MEMORANDUM FOR: Chairman Palladino
 Commissioner Gilinsky
 Commissioner Roberts
 Commissioner Asselstine
 Commissioner Bernthal

FROM: Darrell G. Eisenhut, Director
 Division of Licensing
 Office of Nuclear Reactor Regulation

SUBJECT: DIABLO CANYON - ALLEGATIONS CONCERNING SMALL BORE PIPING
 AND SUPPORTS (Board Notification No. 83-171)

Enclosure

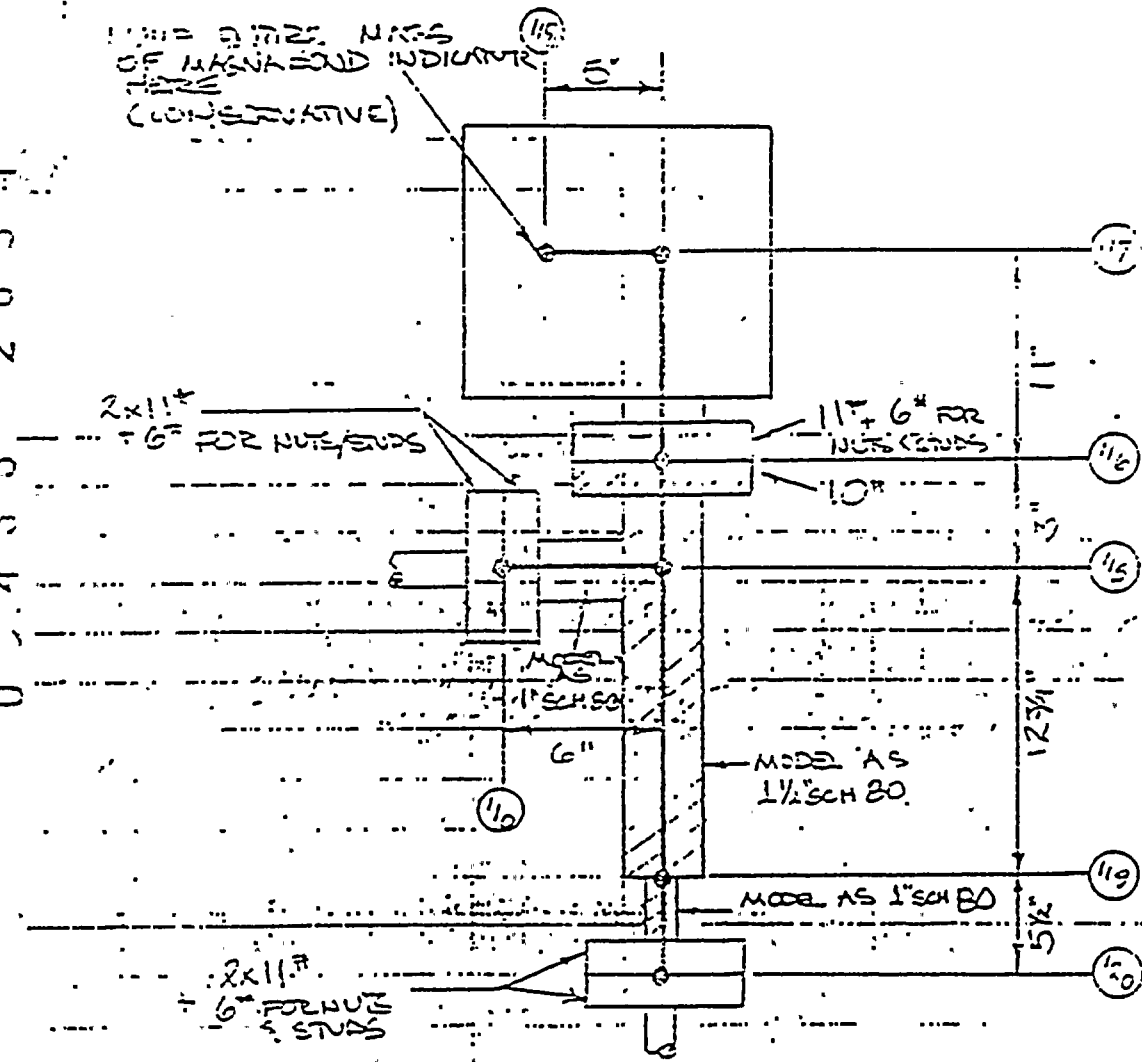
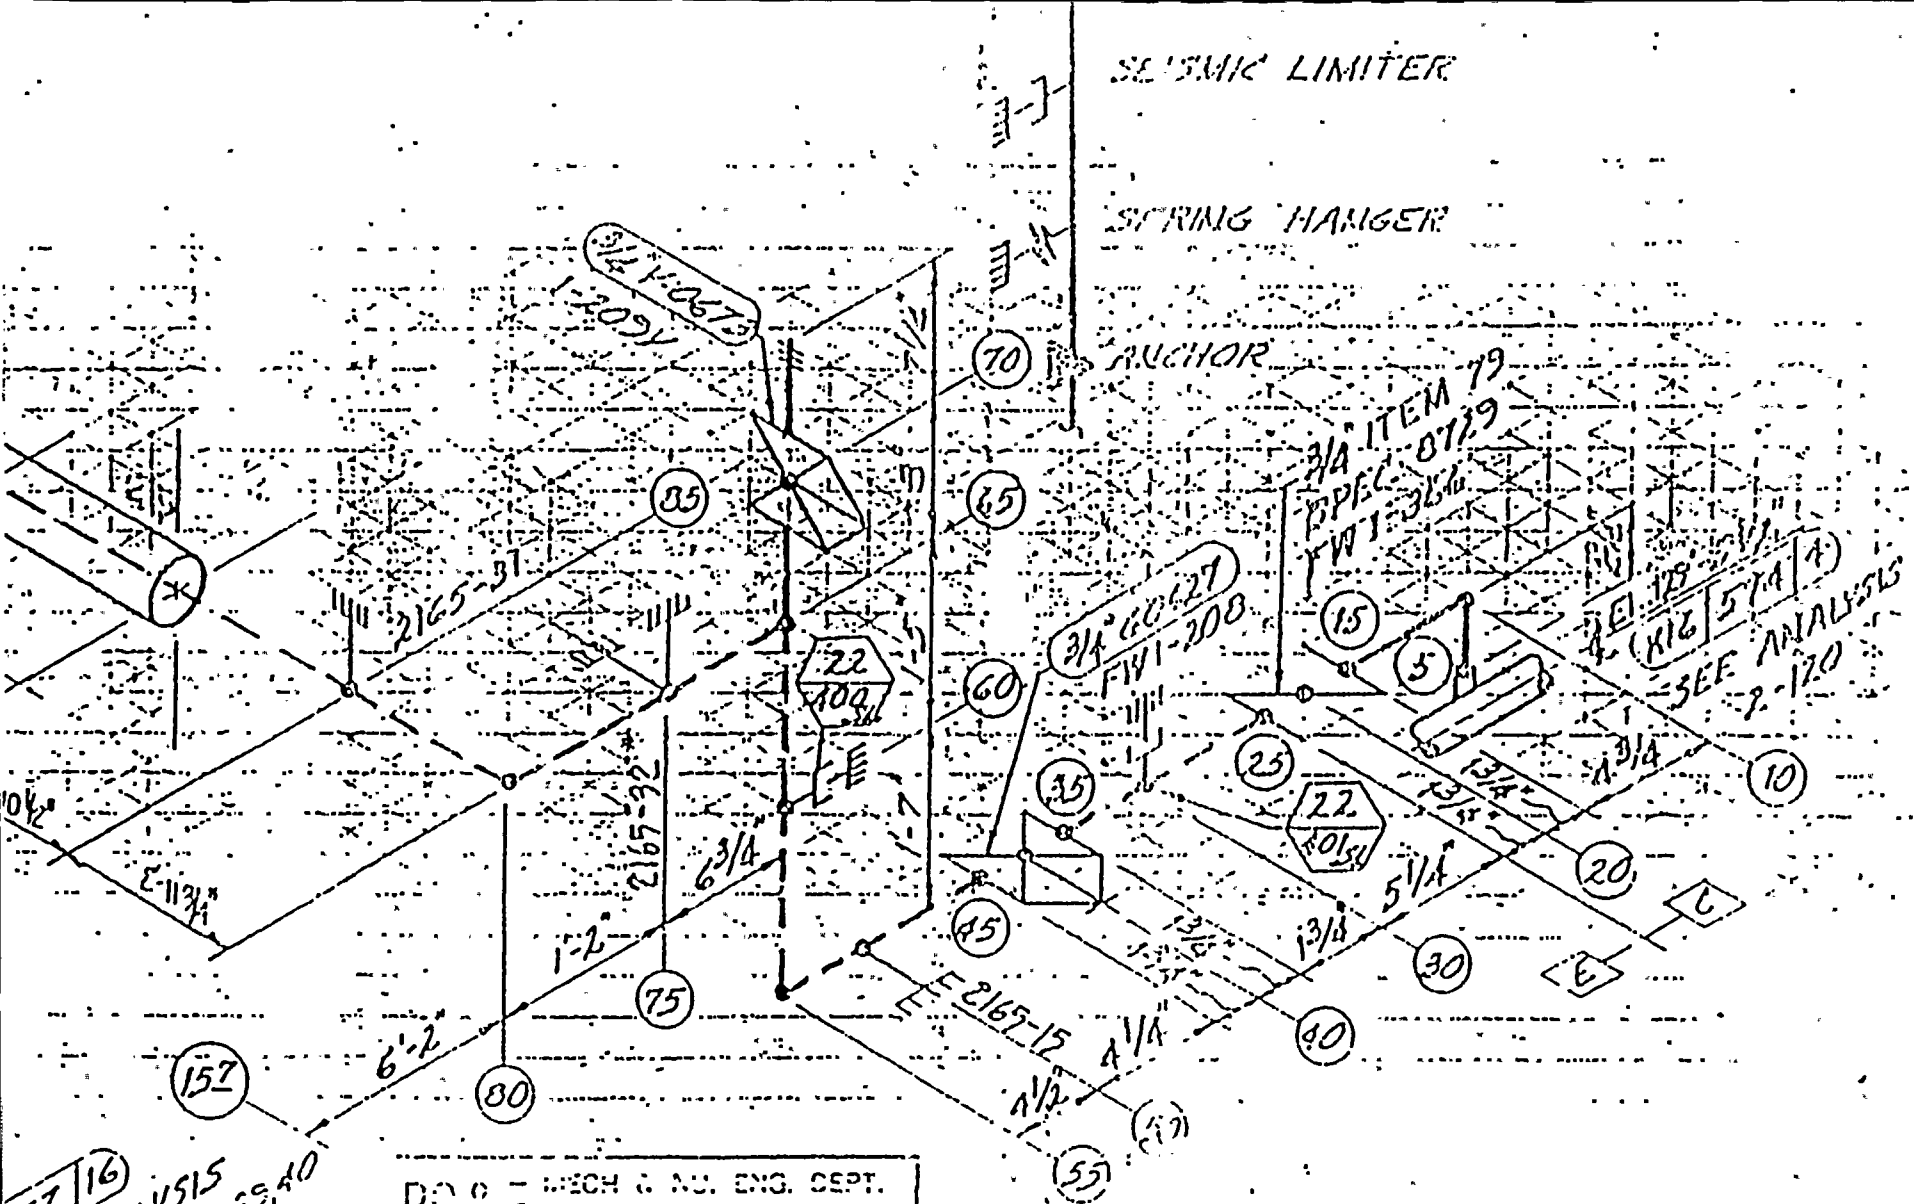
The lateral seismic movements calculated at data point 85 are $\Delta X(DE)=2.817''$, $\Delta X(DDE)=5.633''$, and $\Delta X(HS)=8.162''$. The drawing shows the existence of a wall penetration 2'-10 1/2" from data point 85. This wall penetration will restrict the seismic deflection of the pipe to 5-5/8" laterally at any point in the penetration. Because of this penetration, the maximum deflection at data point 85 is expected to be approximately 2-1/8" which is comparable to the "DE" case where stress would be proportional to deflection. Clearly, it can be concluded that the seismic stresses in the piping will be significantly less than those calculated.

ANALYSIS E-313 WAS INITIALLY REQUESTED BY THE PIPE SUPPORT GROUP TO CERTIFICATE THAT STRESSES IN THE REGION BETWEEN SUPPORT RIGS 32 AND LINE RIG 574 (NODE 5-75) WERE ACCEPTABLE. THE ANALYSIS BOUNDARY WAS EXTENDED TO LINE RIG 557 TO INSURE THAT SELF-WEIGHT EXCITATION CONTRIBUTIONS FROM THE NON-SEISMICALLY SUPPORTED PORTION OF LINE 2477 WERE INCLUDED. THE RESULTS OF THIS ANALYSIS SHOWED THAT PIPING IN THE REGION OF CONCERN (NODE 5-75) WAS SEISMICALLY OVERSTRESSED (100% HBS PSI @ NODE 5). THE REGION WAS ALSO THERMALLY OVERSTRESSED AT NODE 5 (RATIO = 1.005 - EXCEEDED). THE FUNDAMENTAL PROBLEM WAS TO REDUCE SEISMIC STRESSES WHICH

FOR THE PURPOSES OF THIS ANALYSIS, THE ANALYSIS WAS TERMINATED AT NODE 75. HOWEVER, THERMAL ANCHOR MOVEMENTS AT NODE 135 ARE SUBSTANTIAL AND THE NON-SEISMICALLY SUPPORTED PIPING BEYOND NODE 75 WAS RETAINED IN THE ANALYSIS TO SUBSTANTIATE THAT THE ADDITION OF THE CODE BREAK ANCHOR WOULD NOT CAUSE THERMAL OVERSTRESS IN THE CLASS PIPING. SEISMIC STRESSES AND LOADS IN THE REGION OF NODE 75 TO 135 ARE THEREFORE NOT NOT APPLICABLE TO THIS ANALYSIS.

LAABLO CANYON NUCLEAR POWER PLANT UNIT NO. 1
 113-212 (VIAWAD 7-15-03)

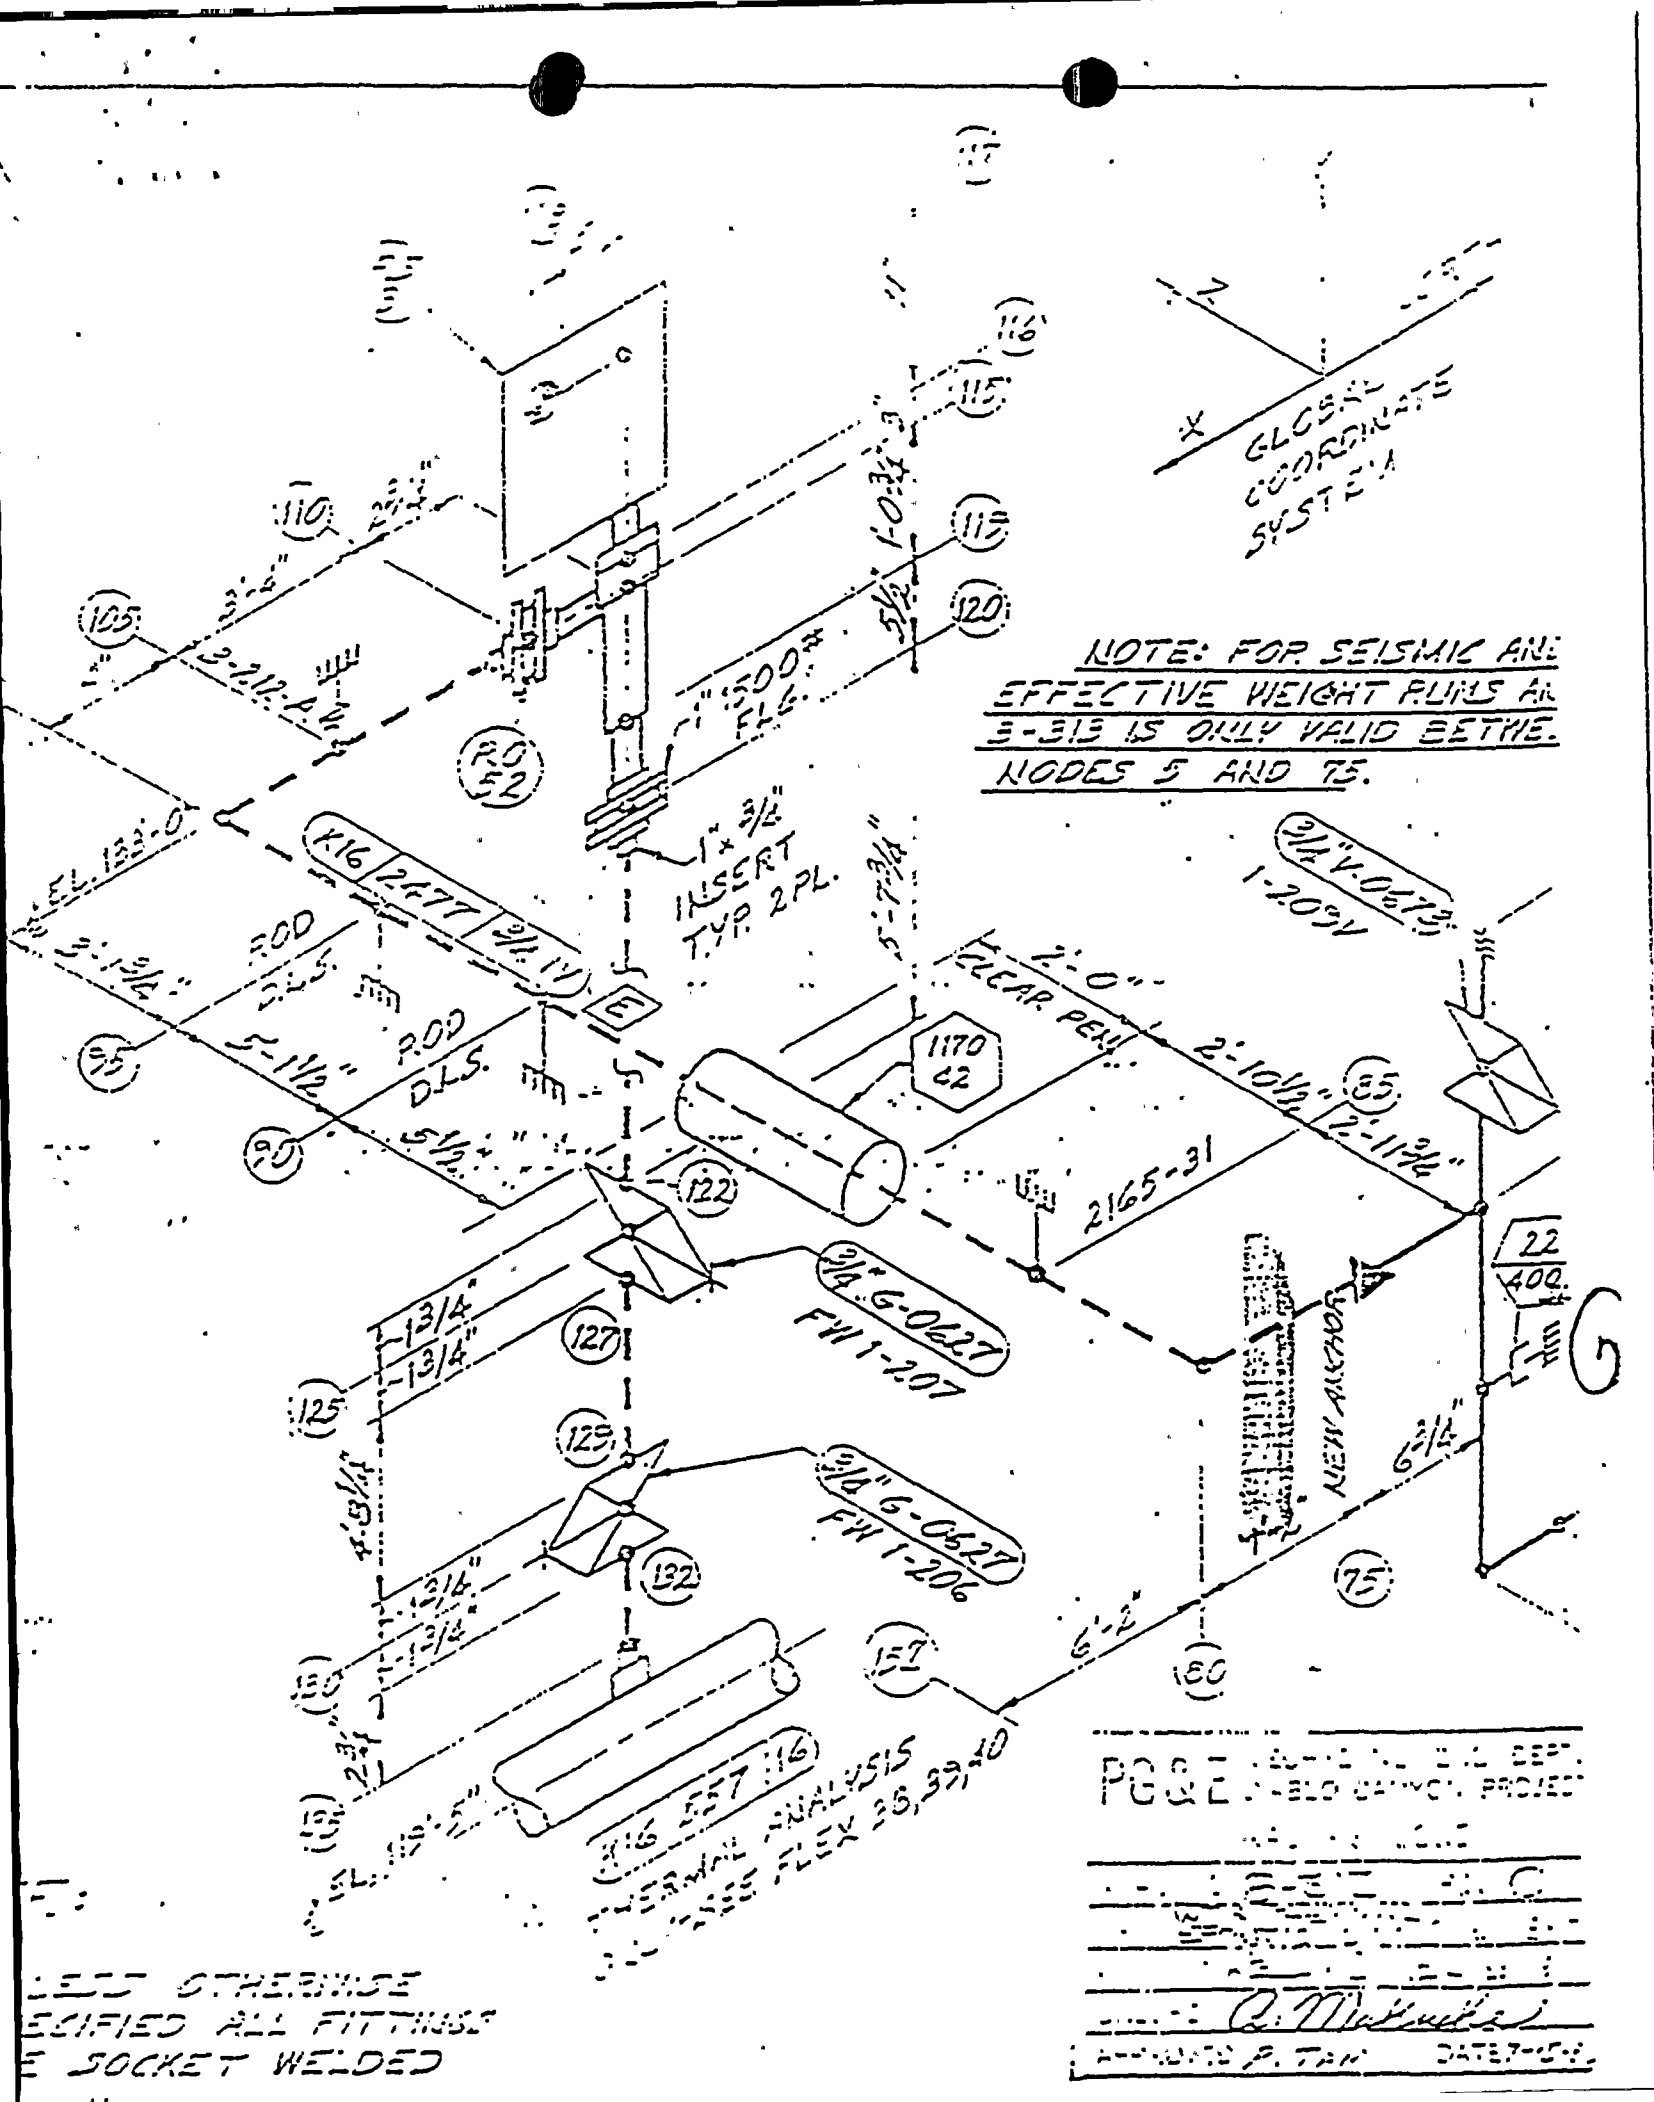
THE PRINTED VALUES IN THE STRESS RATIOS REFLECT VALUES IN THE NON-EMERGENCY PORTION OF THE TABLES, THEREFORE NOT VALID IN AN EMERGENCY CODE BREAK SITUATION (NODE 5 TO 75) AND CORRECTED VALUES ARE...
